Appln No. 09/960,536

**Reply to Office action of December 20, 2004**

**Amendments to the Drawings:**

**FIG. 2**

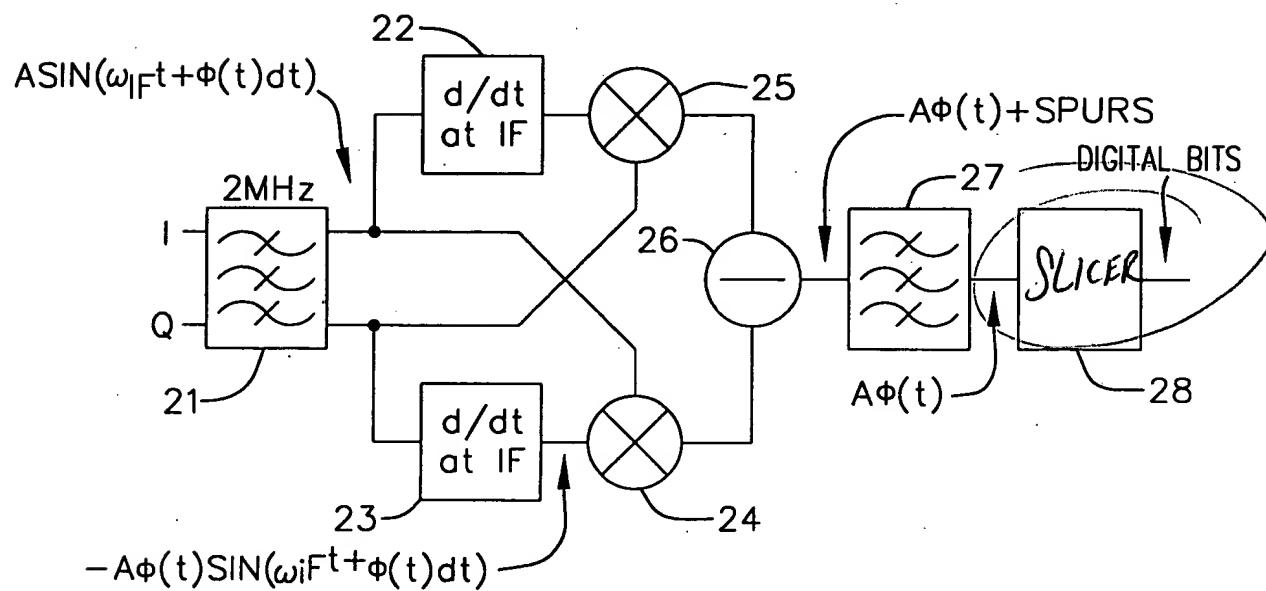
The attached 5 sheets of drawings includes changes to Figure 2 and Figure 7. These 5 replacement sheets, which includes Figs. 2 and 7, replace the original drawings as filed.

Drawings are objected to because of minor informalities. In view of the amendments to FIGs. 2 and 7, it is respectfully requested that the above objections be withdrawn.
